RIO ALGOM CORPORATION

Lisbon Mine

November 4, 1981

Subsequent to your letter of 22 September, 1981, issuing Amendment No. 10 to our Source Materials License, we have been forced by current uranium market conditions to reduce our operation to half production. The need for additional tailings capacity will therefore be accordingly reduced and, in order to conserve cash expenditure at this stage, we plan to raise the lower tailings embankment by 15 feet instead of the approved 25 feet. Your approval of this plan is therefore requested.

AVAILABLE FLOOD STORAGE RELATIONSHIPS
FOR LOWER TAILINGS POND

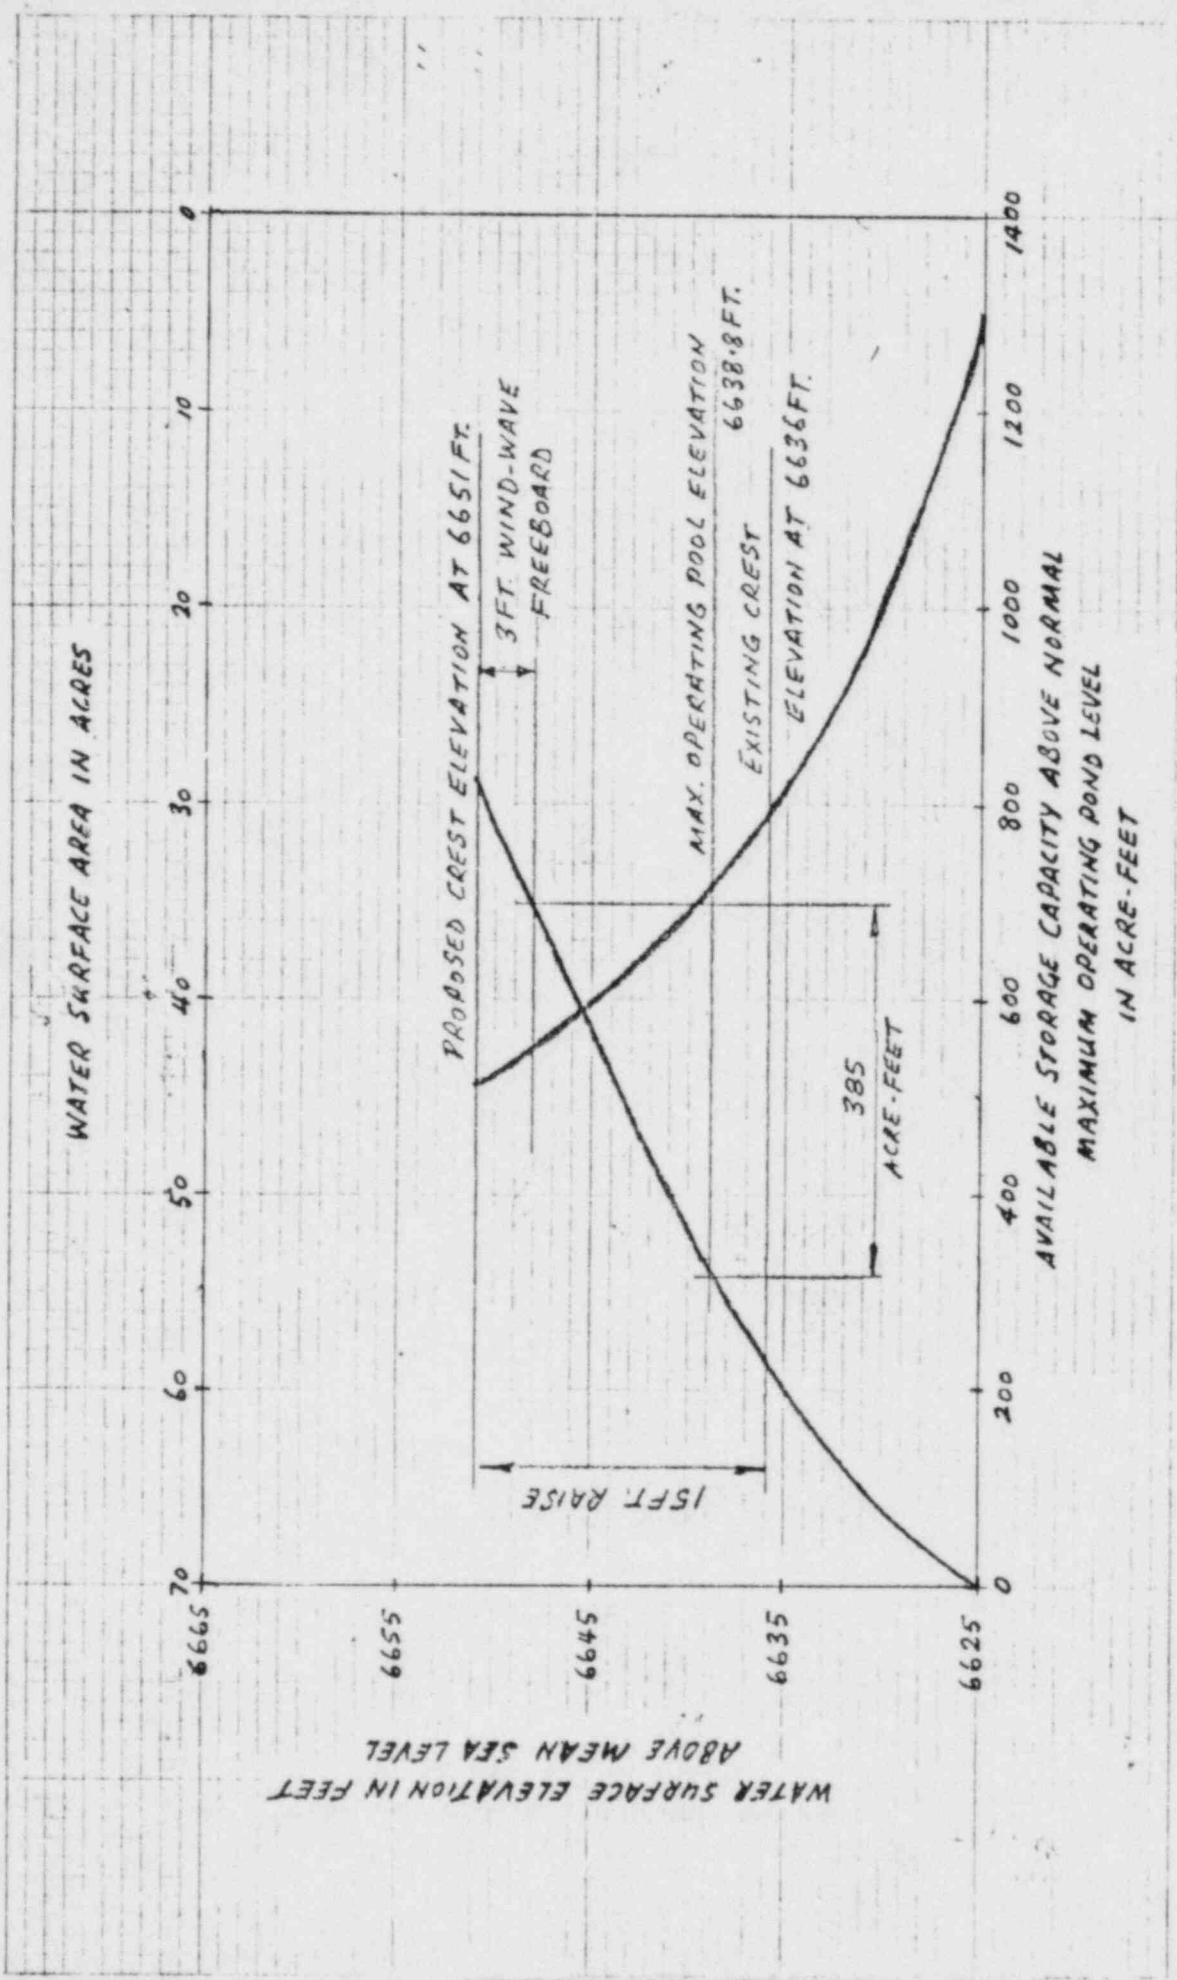
Stability analyses for 10 foot and 25 foot raises of this embankment were submitted to and approved by the Commission in our submittals dated 4 March and 17 March, 1981 respectively, and therefore, since the required raise lies within this range and because the same basic design configuration will be used, it should be unnecessary to spend additional funds for a 15 foot raise stability analysis. However, with the lesser raise it will be necessary to provide a greater freeboard and this is shown to be 12.2 feet on the enclosed flood storage graph. The plan is also to remove all the potentially collapsible material at the toe of the existing embankment that would be required for a 25 foot embankment raise. We consider this to be safer and more economical in the long term and the details of this are shown on a typical embankment cross section on sheet 3 of 8 of the construction drawings of our consultant's report entitled, "Technical Specifications for Tailings Dam Improvements and Flood Control Structures, Lisbon Valley Operations, Near Moab, Utah Rio Algom Corporation" dated 14 October, 1981, which is enclosed.
